STAFF REPORT AMENDED 3-22-84
CITY PLANNING COMMISSION

LOCATION: 5888 Riverside Boulevard

PROPOSAL: The applicant is requesting the necessary entitlements to construct a 180-seat restaurant and accompanying parking along the Sacramento River Parkway in the Flood (F) and Single Family (R-1) zones.

EXTERIOR ELEVATIONS

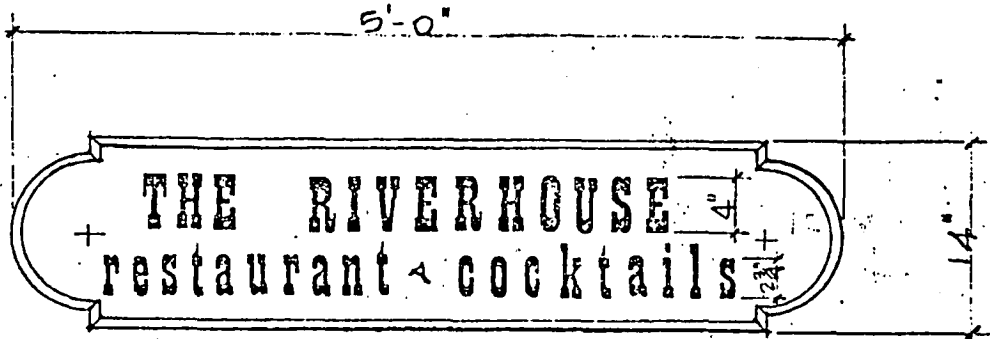
4. A condition of the original special permit approval required review of the project by the Design Review Board. On February 10, 1983 the Design Review Board determined that the structural elevations adhere to the "river warehouse" specified design concept. The design was approved with conditions relating to shading of structural glazing. The building will be constructed of horizontal redwood siding, resawn redwood board and batting and corrugated iron siding. Colors will be earth tones with green trim. The roof will be of factory colored metal corrugated material. Ten-foot pole lanterns will provide lighting for the building and parking area.

- k. The applicant shall comply with the following Design Review Board conditions:
 - 1) Thirty percent transparency glass on the ground level west facade;

- 2) Canvas awnings over the west facing and south facing windows at ground level;
 - 3) A roll-down canvas to be provided under the overhang on the west facing clerestory.

RIVERHOUSE RESTAURANT
BUILDING SIGN PLAN

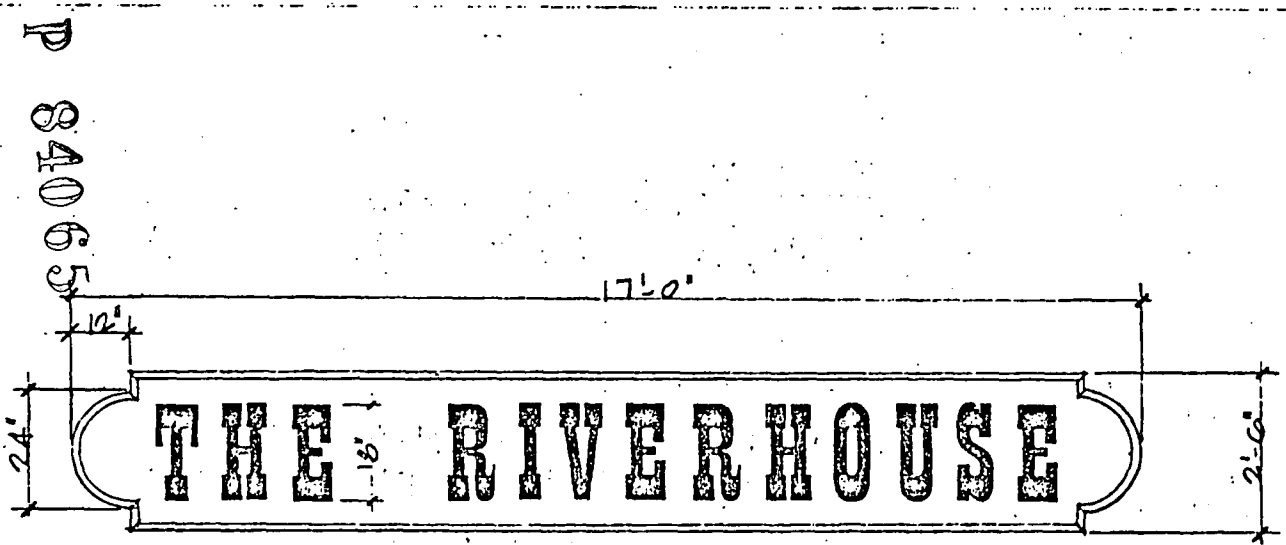
5. A sign is indicated on the roof facing both the river and the freeway. This is a violation of the Sign Ordinance (Sec. 3.156) unless a special permit is obtained. Other signage on the site was reviewed by the Design Review Board. Graphics and design were found to meet Design Review Board guidelines. Location and size of signs must comply with sign ordinance regulations.

- l. Signage shall be reviewed by Planning staff for compliance with Sign Ordinance regulations prior to issuance of building permits.
- m. *Dockage, if any, will require modification of the special permit, and will be submitted for Planning Commission review and approval.*
